Meeting Date: May 26, 2021
Item Number: 2

PLANNING COMMISSION AGENDA REPORT

SUBJECT: Review of a Tentative Tract Map (Tract 3157) to create 23 residential lots on a 4.98-acre site within the Low-Density Residential (R-1) zone. Project includes the extension of Stanford Drive, which will connect to an extension of Cuesta Drive. An Initial Study/Mitigated Negative Declaration is proposed (CEQA).

PROJECT ADDRESS: 468/500 Westmont Ave. **BY:** Kyle Van Leeuwen, Associate Planner
 Phone Number: (805) 781-7091
 E-mail: kvanleeuwen@slocity.org

Figure 1: Subdivision Design Circulation Connections

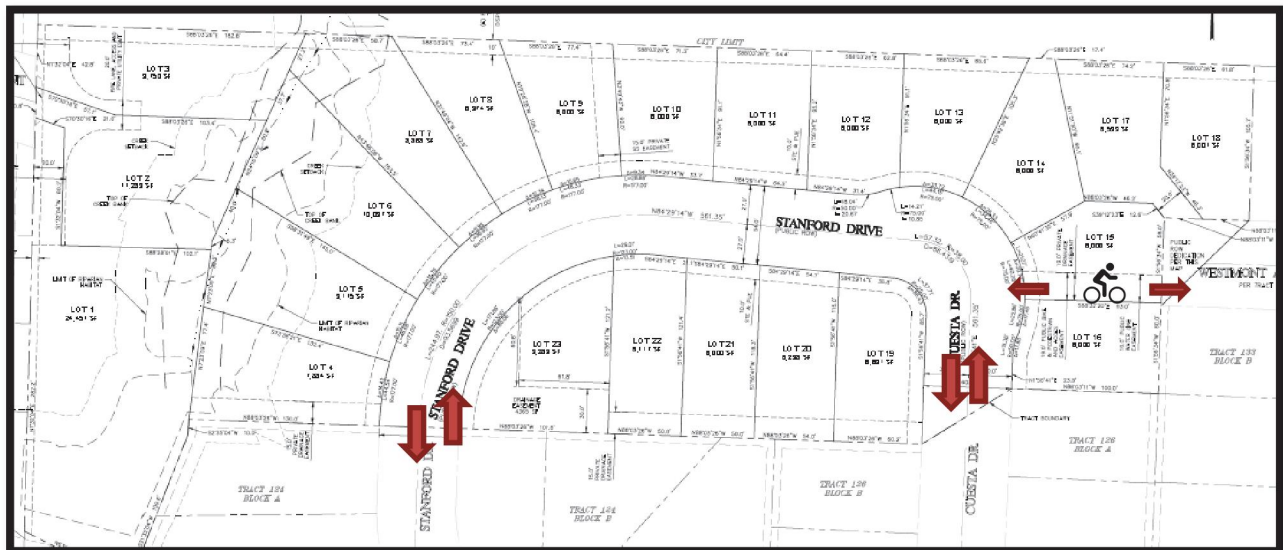
The design of the subdivision protects the existing neighborhood from intrusive traffic by only connecting the two existing streets to the south, avoiding any increase in cut-through traffic between other existing neighborhoods and Highway 1. The subdivision design also incorporates a potential bicycle and pedestrian connection to the east, as well as parkways, on-street parking, and sidewalks.

Figure 2: Cuesta Drive Street Design Connection to Existing

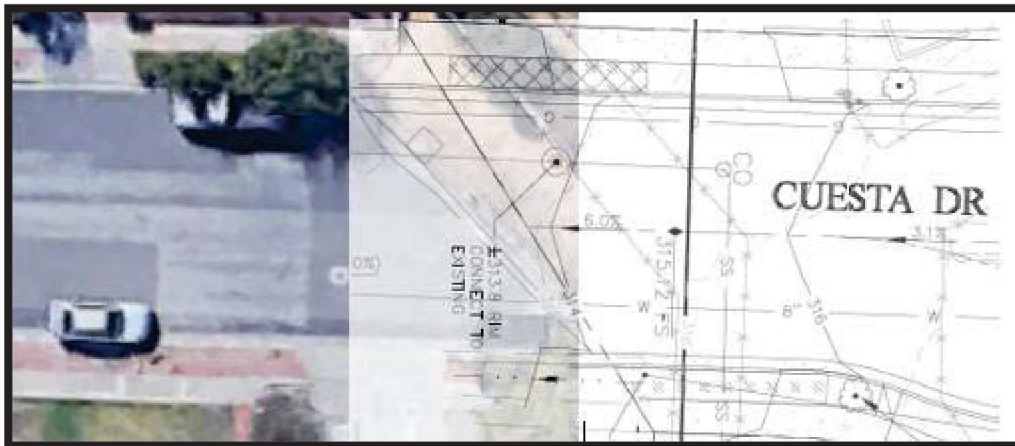
The design of the subdivision integrates with the existing neighborhood by continuing the street layout of Stanford and Cuesta Drive, including street width, sidewalks, and parkways (see Figure 2 as example).

Figure 3: Creek Corridor, trees number in black within setbacks are retained

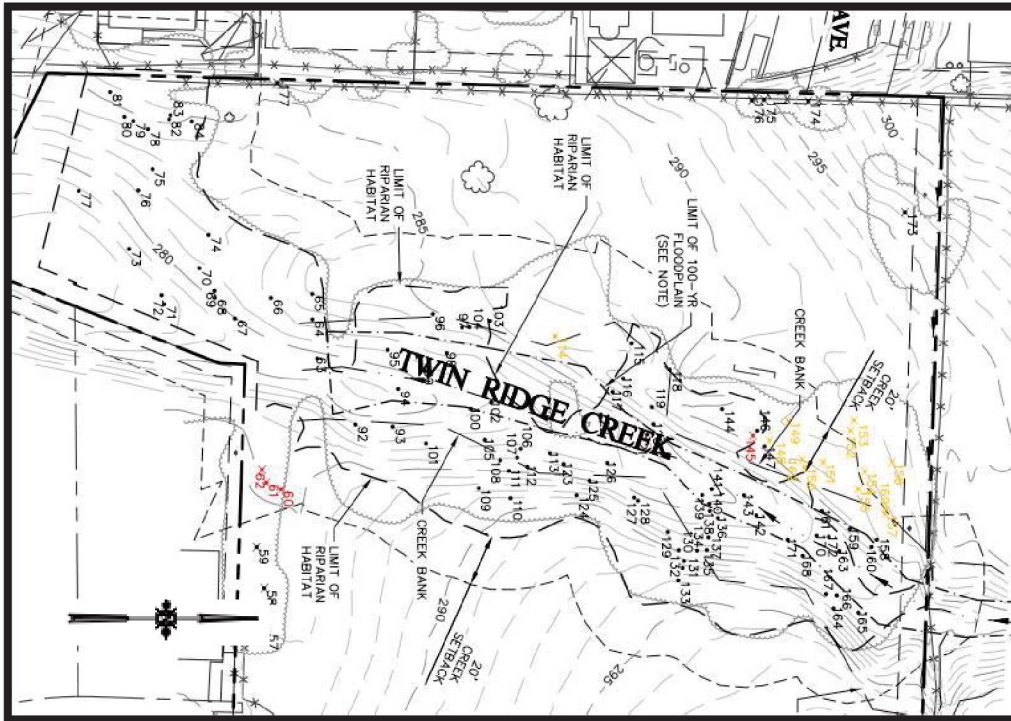
The TTM identifies the dimensions of the creek and existing riparian area. The lots proposed adjacent to the creek are a larger size so that creek protection measures, such as compliance with creek setback requirements, can be met and still allow development of the created parcel. The TTM also proposes no development or grading activities in the southwest corner of the site, where the creek and associated vegetation is most prominent and established. In all, over 60 coast live oaks, will be retained within the protected creek corridor area, as well as other native species.
